**Environmental  
Planning  
Commission**

**Agenda Number: 02  
Project Number: 1001754  
Case #: 16EPC-40039  
September 8, 2016**

**Staff Report**

| <b>Request</b>           | <b>Site Development Plan for Building Permit</b>          |

**SITE INFORMATION**

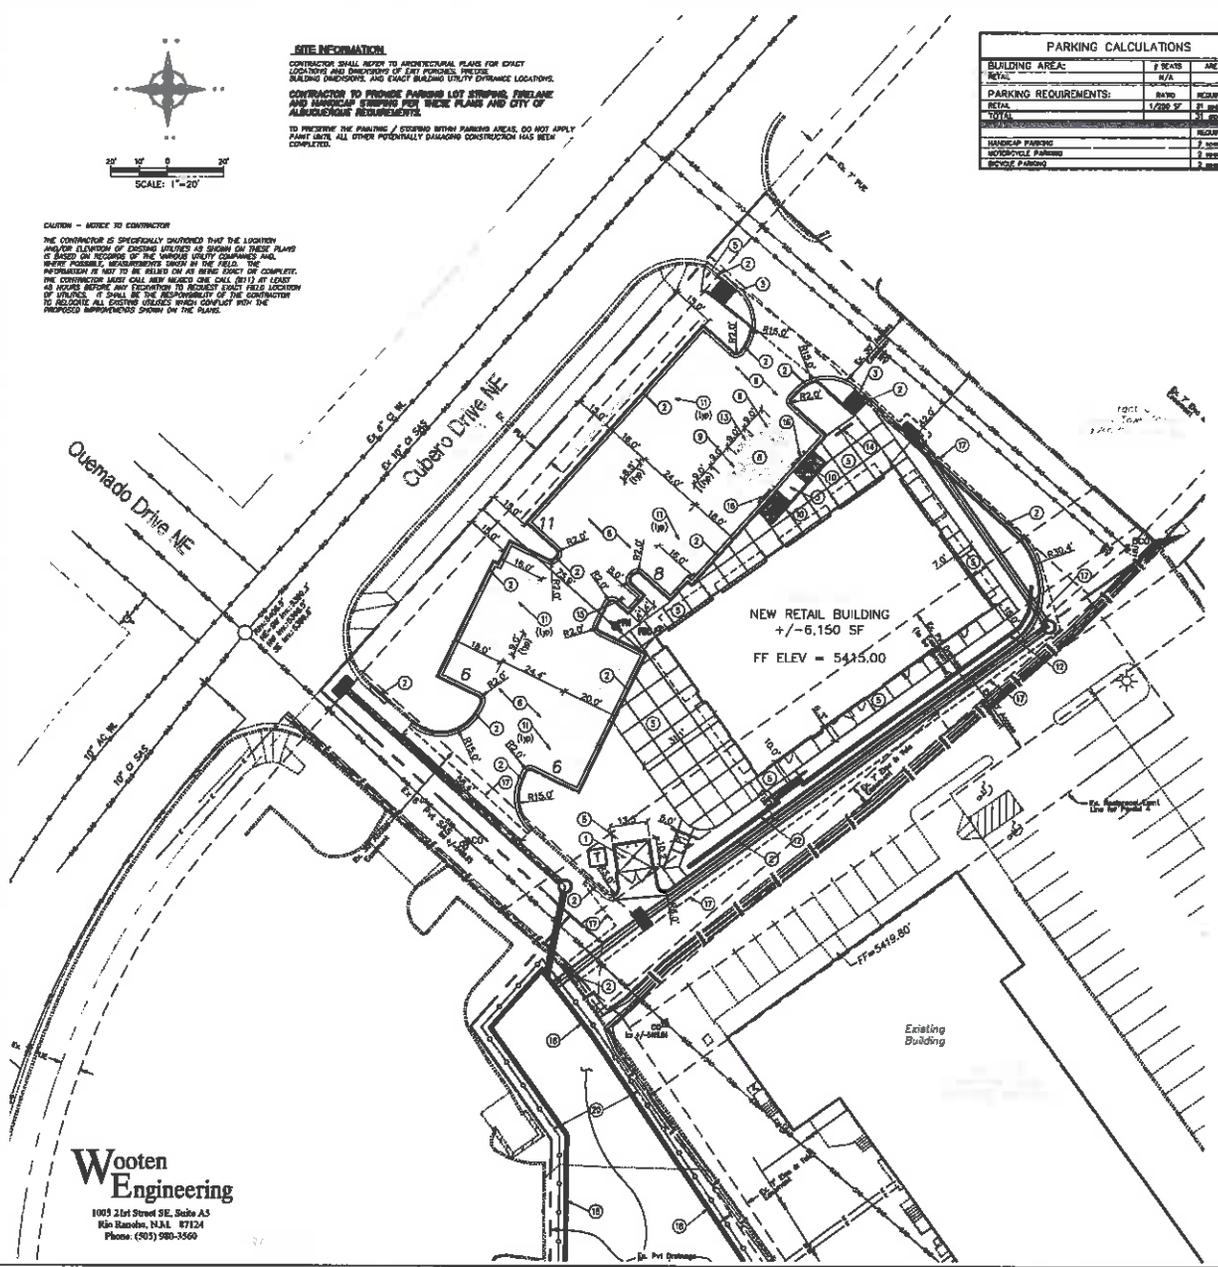
- *For both drive aisles, show a pedestrian crossing of the drive aisle as either striped and/or of a material other than asphalt.*
- *From the southwest edge of the site, a pedestrian path from the sidewalk and the drive aisle crossing to the front door would benefit customers coming from the adjacent neighborhood.*

1. Identify all existing access easements and rights of way width dimensions.
2. Per DPM, a 6 ft. wide ADA accessible pedestrian pathway is required from the public sidewalk to the building entrances. Please clearly show this pathway and provide details.
3. Please dimension motorcycle parking spaces.
4. Please add the following note to the clear sight triangle: "Landscaping and signage will not interfere with clear sight requirements. Therefore, signs, walls, trees, and shrubbery between 3 and 8 feet tall (as measured from the gutter pan) will not be acceptable in this area."
5. Add a note "All broken or cracked sidewalk must be replaced with sidewalk and curb & gutter." A build note must be provided referring to the appropriate City Standard drawing.

- The storm drain appears to cross several tracts, so it will need to have a storm drain easement with beneficiaries and maintenance listed.
- If it is a restaurant, the trash enclosure area should be connected directly to the SAS.
- The roof drains should not spill directly onto sidewalks, particularly along the ADA path.
- The site plan should at least state how the first flush volume will be managed.
- Applicant made submittal for DRB, additional specific comments may be provided through that review

See city spec's for minimum standards on solid waste enclosure. Specs on plan do not meet minimum standards.

Long Range Planning made a comment regarding this, stating that a pedestrian walkway should exist on the west side of the property and make a connection to the building from the southwest corner of the subject site. The applicant has added a sidewalk connection from the building to the southwest corner where the dumpster is located; however, no sidewalk was proposed or added along the west side of the subject site. The agents responded to the comment by stating that they observed the northeast corner as the primary connection into the development and that adding a connection on the west side to the southwest corner would not be shorter or more convenient than what is proposed. Placing the sidewalk along the west side would also require the removal or significant reduction of stormwater quality ponds that are required for Hydrology. Full email responses from the agents can be found in the additional staff information section at the end of this report.

- c. Identify all existing access easements and rights of way width dimensions.
  - d. Per DPM, a 6 ft. wide ADA accessible pedestrian pathway is required from the public sidewalk to the building entrances. Please clearly show this pathway and provide details.

- 
- e. Please dimension motorcycle parking spaces.
  - f. Please add the following note to the clear sight triangle: "Landscaping and signage will not interfere with clear sight requirements. Therefore, signs, walls, trees, and shrubbery between 3 and 8 feet tall (as measured from the gutter pan) will not be acceptable in this area."

- g. Add a note "All broken or cracked sidewalk must be replaced with sidewalk and curb & gutter." A build note must be provided referring to the appropriate City Standard drawing.
